NPF-38-172

ATTACHMENT B

# **PROPOSED**

# TABLE 4.8-1a

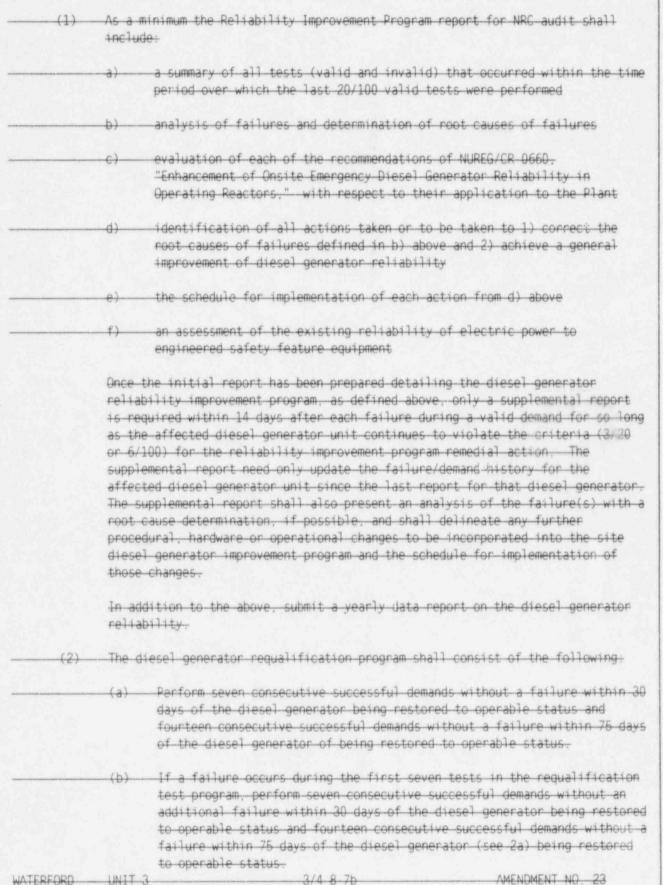
No. of failures in last 20	No. of failures in last 100	HOPUSED
valid tests	valid tests	Action
3	6	Within 14 days prepare 2nd maintain a report for NRC audit describing the diesel generator reliability improvement program implemented at the site (see Note 1).
5	11	Declare the diesel generator———————————————————————————————————

## TABLE 4.8-1a (Continued)

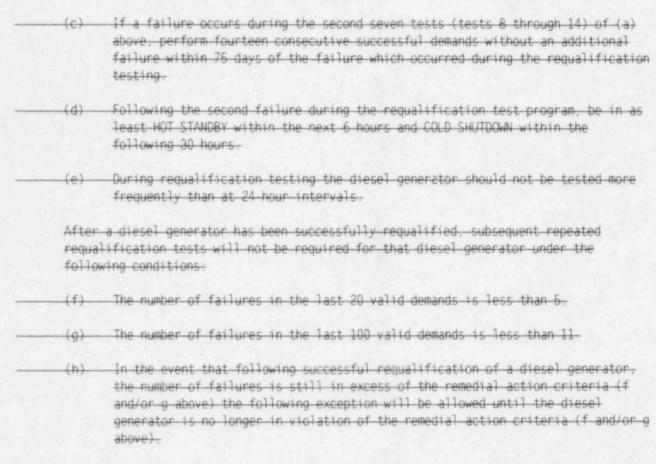
Requalification testing will not be required provided that after each valid demand the number of failures in the last 20 and/or 100 valid demands has not increased. Once the diesel generator is no longer in violation of the remedial action criteria above, the provisions of those criteria alone will prevail.
